MINUTES OF THE PLANNING & ZONING COMMISSION

May 24, 2023

B. North Smyrna Elementary School, #SP-2023-002, 365 North Main Street, 1-17-01013-01-0100-00001

C. Goldsborough Road Development, #SP-2023-003/#SD-2023-001, 1705 Goldsborough Road, 28-001.00-003

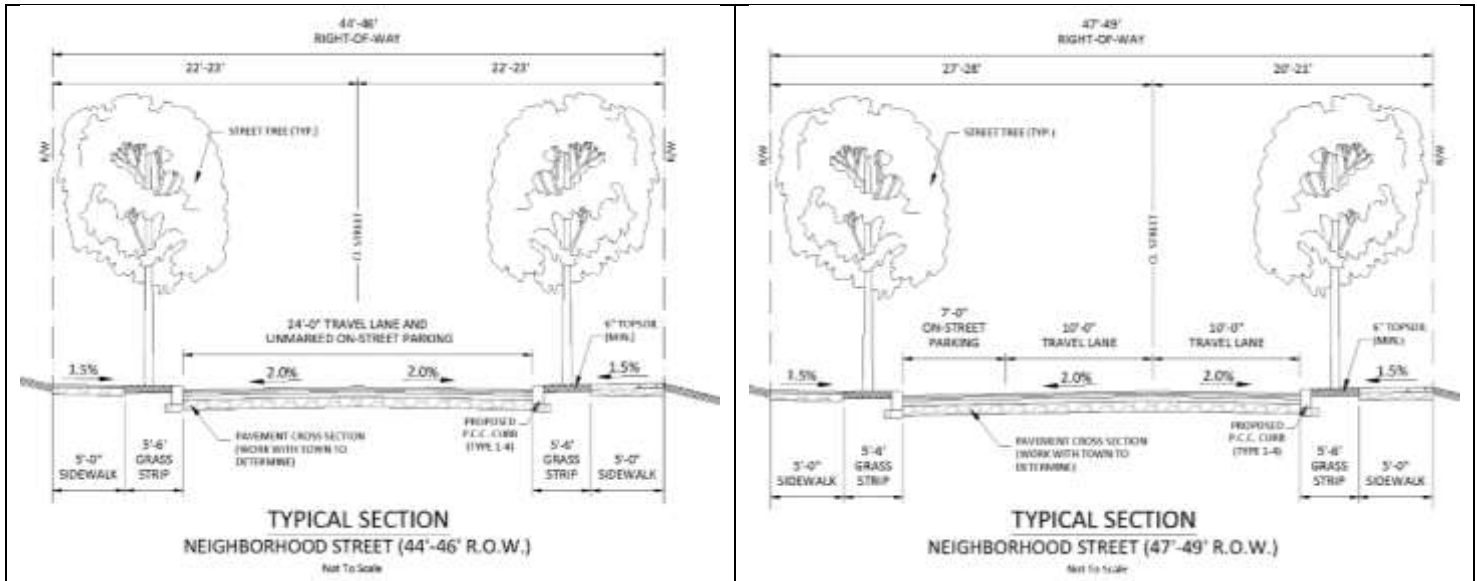
- (j.) *Traffic calming measures, including but not limited to, curb extensions, medians, narrower "queuing" travel lanes, and traffic circles should be used wherever possible to slow vehicular traffic within the neighborhoods.*

Staff response: Curb extensions (also known as bulb-outs) have been proposed along all boulevard-type and neighborhood streets. The applicant meets this section of the Code.
